SAVE THE SCENIC
SANTA RITAS
ASSOCIATION

RE: CLEAN WATER ACT 404 PERMIT FOR THE PROPOSED ROSEMONT COPPER MINE

Figure 9. A photograph of the slag and former smelter site from Google Earth (outlined in black). Needs and opportunities for remediation of this site, which may be contributing to degraded water quality, have not been investigated.

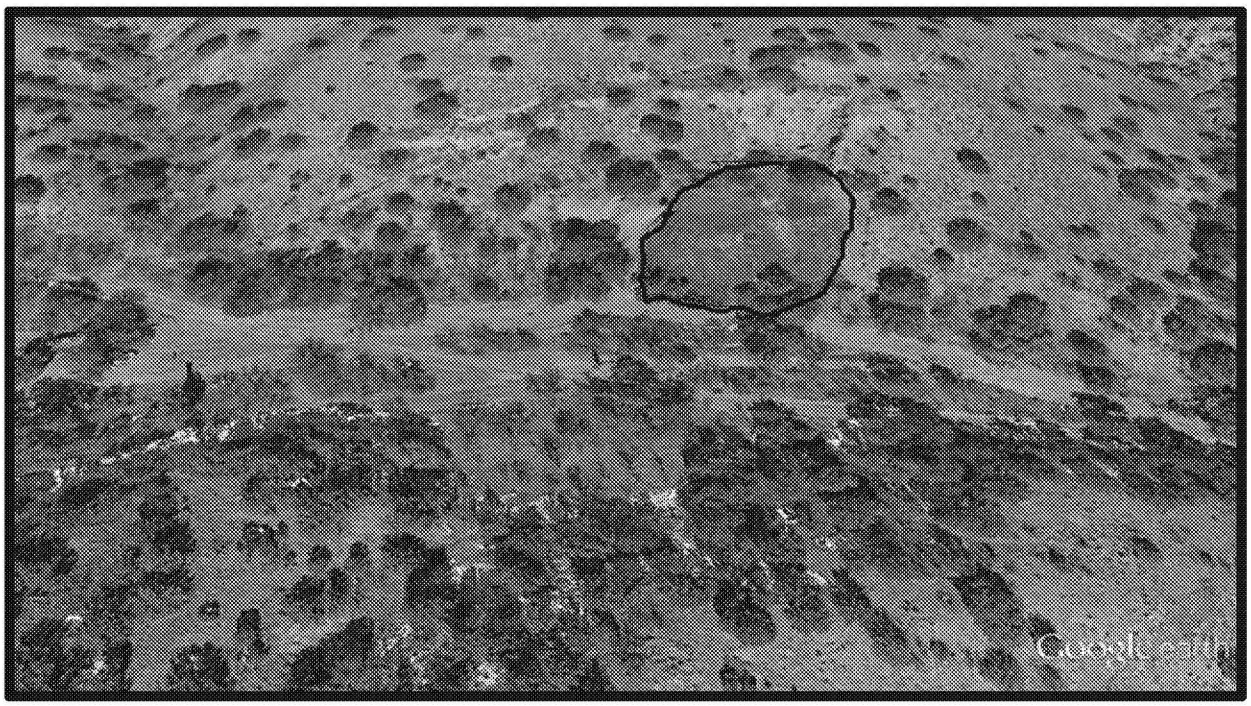
A smelter operated along Wasp Canyon just upstream of its confluence with Barrel Canyon from 1879 to 1905, and was subsequently removed. (Tetra Tech 2009 in Appendix 8, and Figure 9 below) The smelter site is exempt from APP regulations per §A.R.S. 49-250(B)(11). The APP applicant proposes to cover the slag pile and remains of the smelter site with new, "dry" tailings. We are unaware of any further site investigation that has been required by state or federal authorities.
